MAIN STREET, CRAFTERS

RAISED WOMBAT CROSSING ASSESSMENT

TECHNICAL MEMO

Figure 5: DIT proposed wombat crossing

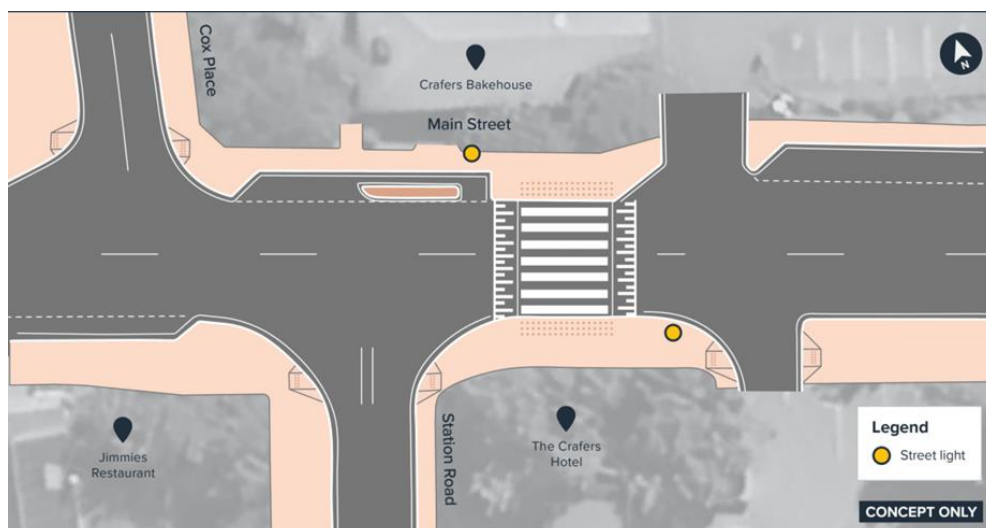
To facilitate the proposed wombat crossing at this location, the existing street lighting will require upgrading to comply with AS 1158.4. In addition, on-street parking will need to be prohibited in the vicinity of the crossing to ensure adequate sightlines, in accordance with DIT's Supplement to AS 1742.10.

The proposed location is currently provided with street lighting, which can be upgraded to meet the lighting requirements for a wombat crossing. The wombat crossing is also expected to provide traffic-calming benefits and contribute to a physical reduction in vehicle speeds, supporting improved compliance with both the existing and proposed speed limits.

Concerns have been raised by adjacent businesses regarding the potential loss of on-street parking and the associated impacts on business operations. However, based on the site inspection undertaken by BEES, along with the Crafers Village Centre Analysis and Opportunities Planning documents, there

BEES investigated alternative locations for the proposed wombat crossing. The only other feasible option identified was to relocate the crossing further west, near the existing bus stops, and to shift the bus stops to the currently proposed crossing location. This option would result in the loss of a similar number of on-street parking spaces compared to the current proposal. In addition, existing light poles would need to be relocated to accommodate the crossing at this location.

The anticipated usage of a wombat crossing at this alternative location is considered to be lower than at the proposed location, as it is further removed from the established pedestrian desire line.

Furthermore, this option would place the wombat crossing in close proximity to the roundabout, leaving a significant portion of Main Street without traffic-calming measures. As a result, it would not adequately address the observed speeding behaviour associated with motorists entering the freeway on-ramp.

Analysis indicates that the current proposal represents the most suitable option, as it is located on the established pedestrian desire line, has minimal impact on existing infrastructure, and provides an effective traffic-calming measure along the section of Main Street closest to the freeway on-ramp.

The available parking supply is considered adequate to support the existing mix of retail and hospitality uses within the village centre, and any loading requirements can be accommodated through timed on-street or off-street loading zones. It is therefore recommended that the proposed wombat crossing remain at its current location.
